# Access Compliance Report

## Public Rights-of-Way

### (Curb Ramps)

Intersection ID: 10029119	Main Street: JAMES_BLAKENEY_AV	Cross Street: N/A	Location: NW
ADA ID: 2621752D5ABE	Ramp Type: PerpDiag	Initial Pass/Fail: Fail	Overall Compliance: No
Severity Score: 33.75			
Codes/Mitigation Info/Possible Solution		Field Measurements/Component Compliance

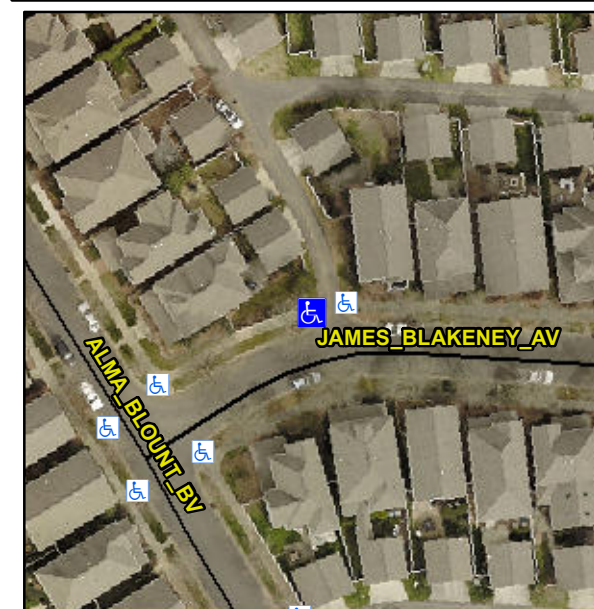
**R304.5.1, R304.2.2**

Compliance	Description	Data	Compliance	Description	Data
N/A	Ramp Length (in)	67.0	No	Ramp Slope (%)	12.1
No	Ramp Width (in)	40.0	Yes	Ramp XSlope (%)	0.5
N/A	Flare Type LT	N/A	N/A	Flare Type RT	N/A
N/A	Flare Slope LT (%)	N/A	N/A	Flare Slope RT (%)	N/A
N/A	Flare Traversable LT?	N/A	N/A	Flare Traversable RT?	N/A
N/A	Landing Length (in)	N/A	N/A	DWS Provided?	N/A
N/A	Landing Width (in)	N/A	N/A	DWS Contrast?	N/A
N/A	Landing Slope (%)	N/A	N/A	DWS Length (in)	N/A
N/A	Landing X Slope (%)	N/A	N/A	DWS Full Width?	N/A
N/A	Landing Curb? (Y/N)	N/A	N/A	DWS Offset (in)	N/A
N/A	Shared Landing?	N/A			
N/A	Gutter Ponding?	N/A	N/A	Gutter Slope (%)	N/A
N/A	Gutter Lip Ht (in)	N/A	N/A	Gutter X Slope (%)	N/A
N/A	Painted X Walk1?	No	N/A	Painted X Walk2?	No
	X Walk 1 Direction	To S		X Walk 2 Direction	To E
N/A	X Walk 1 Width (in)	N/A	N/A	X Walk 2 Width (in)	N/A
	X Walk 1 Slope (%)	0.7		X Walk 2 Slope (%)	0.4
	X Walk 1 X Slope (%)	1.0		X Walk 2 X Slope (%)	1.6

**Remove & Replace Curb Ramp With Two New Directional Ramps or Equivalent.**
